SUBJECT: Review of East Sedona Water Storage Tank, Booster Pump Station and Related Appurtenances, Drainage Report September 2018

Comments Pertaining to Drainage Report dated September 2018

Comments Pertaining to Conditional Use Permit Package Dated April 2018

CD&E has been contracted to review a document titled “East Sedona Water Storage Tank, Booster Pump Station and Related Appurtenances Drainage Report” dated September 2018. The comments listed above provide our detailed comments relating to the Drainage Report and some supplemental comments that pertain to the Conceptual Design Report.

Time of Concentration Calculations

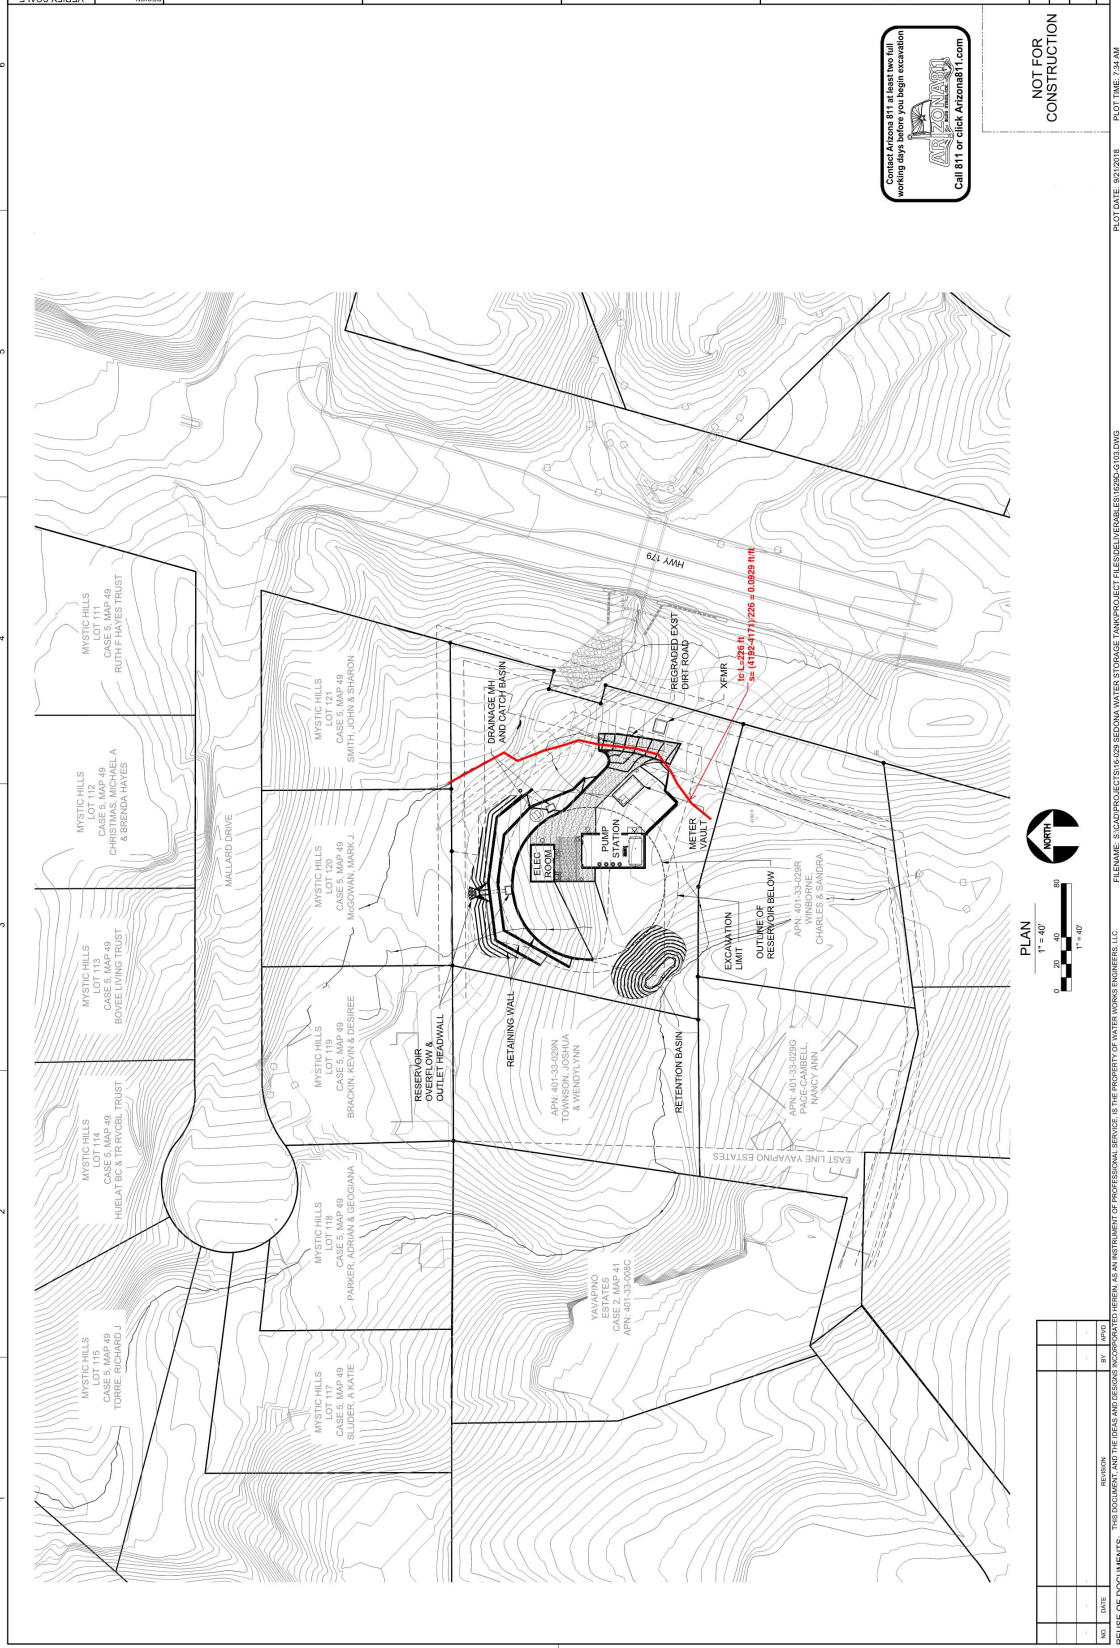
No.	Page	Issue	Comment																
1	3	Description of 2,10,25, & 100, 1-hour storm	<p>i in $Q=cia$ calculation. Per good engineering practices and as explained in the ADOT Drainage Design Manual. "The intensity in $Q=cia$ is the average rainfall intensity in inches/hour for the period of maximum rainfall of a specified return period having a duration equal to the time of concentration for the drainage area." In the calculations provided the author has assumed an intensity 'i' based upon a 1 hour time of concentration (t_c). For this small site the t_c and the related 'i' should be based upon the actual travel path to determine the t_c.</p> <p>The attached illustration depicts a time of concentration path and the related t_c based upon that path. With this path and t_c, the i would be higher resulting in a much higher flowrate. See the tables below for calculations adjusted with 'i' based upon t_c.</p> <p>Existing</p> <table> <tr><td>2 year</td><td>0.94 cfs</td></tr> <tr><td>10 year</td><td>1.69 cfs</td></tr> <tr><td>25 year</td><td>2.31 cfs</td></tr> <tr><td>100 year</td><td>3.24 cfs</td></tr> </table> <p>Developed</p> <table> <tr><td>2 year</td><td>1.47 cfs</td></tr> <tr><td>10 year</td><td>2.65 cfs</td></tr> <tr><td>25 year</td><td>3.62 cfs</td></tr> <tr><td>100 year</td><td>5.09 cfs</td></tr> </table> <p>See attachments A, B and C.</p>	2 year	0.94 cfs	10 year	1.69 cfs	25 year	2.31 cfs	100 year	3.24 cfs	2 year	1.47 cfs	10 year	2.65 cfs	25 year	3.62 cfs	100 year	5.09 cfs

100-year $C_f=1.25$
12	3, 6, 9	2- hour intensity	The Arizona Department of Transportation Drainage Design Manual indicates that t_c shall not exceed 60 minutes if the Rational Method is used. The 2-hour t_c should not be used with this program.
13	Cover	No engineer's seal	The author of the document is not identified. It does not appear that the document was written by a professional engineer.
14	4	Figure 2	Figure 2 "Existing Site Grading Conditions" illustrates that runoff leaves the site in two directions. The design of the retention does not have a proportional amount of storage that relates to the size of the subarea. The larger retention volume is in the smaller watershed and the smaller detention are is located in the larger watershed area. The two areas should be evaluated separately.
15	12	Retention	Retention is not typically used in northern Arizona, due to the poor percolation rates. Typically detention is used in Northern Arizona. The difference is a release at the bottom of the detention basin that is small and controls the discharge rate to pre-construction rates.
